REMARKS

APPENDIX A

Two Sheets of Annotated Marked-Up Drawings

AMENDMENT IN RESPONSE TO OFFICE
ACTION DATED FEBRUARY 23, 2005

FIG. 3C 3D

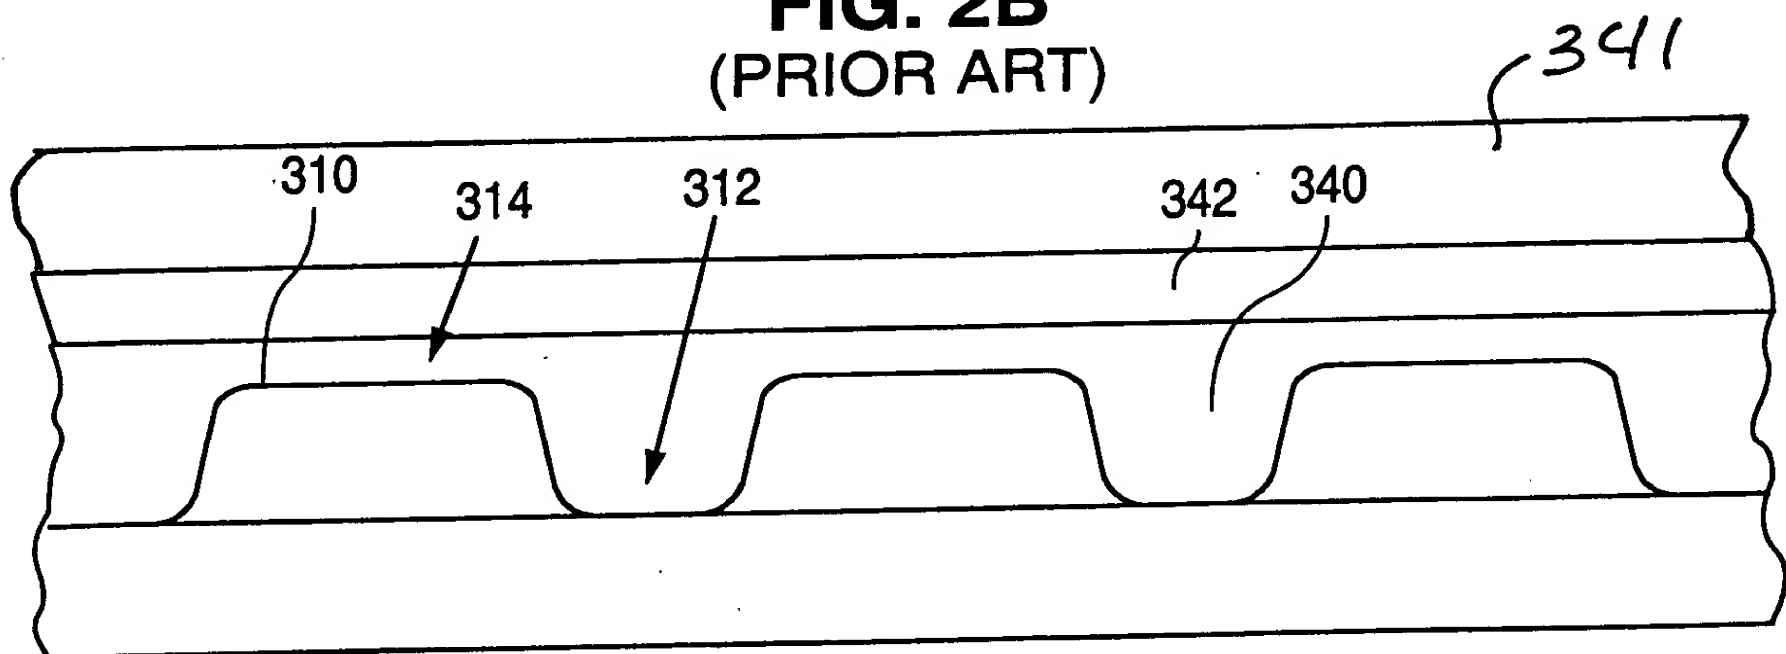
Applicant requests the Examiner's permission to amend the drawings as shown in red on the attached two sheets of annotated marked-up drawings. The annotated marked-up drawings, which are attached as Appendix A, changes FIG. 3C to FIG. 3D, adds a mask 341 in new FIG. 3D, and adds a new FIG. 3C that illustrates the formation of mask 341 on planarized polysilicon layer 340. In addition, two replacement drawing sheets that include the changes are attached in Appendix B. Further, the specification has been amended to reflect the reference numerals.

The Examiner objected to the amendment mailed on March 15, 2002 under 35 U.S.C. §132 as introducing new matter into the disclosure. In objecting to the amendment, the Examiner indicated that there is support for the formation of a layer of third material over a planarized layer of material, but argued that there is no support for a layer of material 342 that lowers resistance.

"As shown in FIG. 3D, a layer of material 342 is formed over planarized polysilicon layer 340." (See the fifth paragraph of page 5, as amended above.)

The phrase "that lowers resistance" has been deleted. Thus, from what applicant can determine, no new matter has been introduced into the disclosure.
